28 REHABILITATION AND CLOSURE

28.1 ADEQUACY OF ASSESSMENT

28.1.1 REHABILITATION AND CLOSURE PLAN

Figure 28.1 Life of Olympic Dam mine compared to other mines

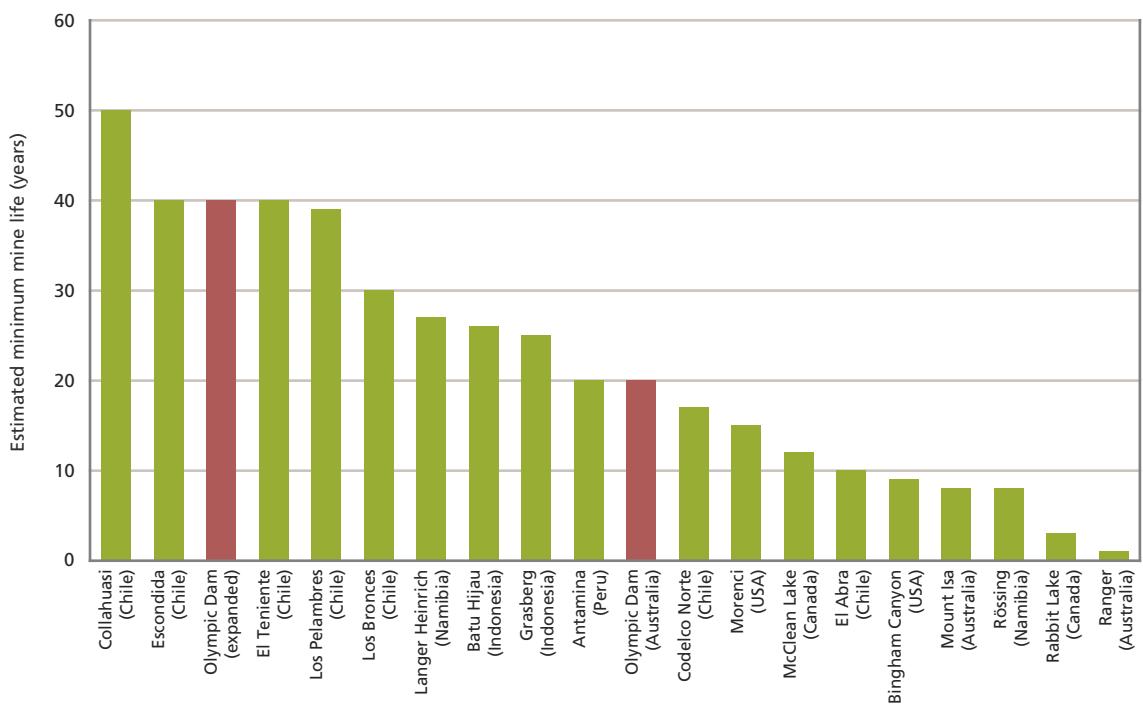
Concern was raised that a closure plan was not detailed in the Executive Summary of the Draft EIS. It was also suggested that a detailed closure plan should be submitted to the South Australian Government before it decided whether to approve the expansion project or not.

The Draft EIS presented the assessment of an expanded operation over 40 years. However, the ore body at Olympic Dam is so large that the life of the mine could continue well beyond 40 years (as presented in Figure 3.9 of the Draft EIS and reproduced here as Figure 28.1). BHP Billiton has extensive experience with long-lifespan mines, such as the Escondida copper mine in Chile. It adopts a dynamic approach to planning for closure, so that new technologies and revised standards can be incorporated to more easily accommodate stakeholder requirements, which may change over the long term. As discussed in Chapter 23 of the Draft EIS, it is unclear from the outset whether all components of the mining operation would be closed at the same time. For example, the desalination plant at Point Lowly and the port infrastructure at the Port of Darwin may be left in place to service the government, local community and/or other industries. Decisions regarding the future of each component would be made in close consultation with relevant stakeholders and on an ongoing basis throughout the life of the mine. This approach facilitates consideration of variables (e.g. advances in technology, changes in land use, climactic conditions, and the future political, social and economic environment) that may influence the decision-making process, but cannot be easily predicted so far in advance of mine closure.
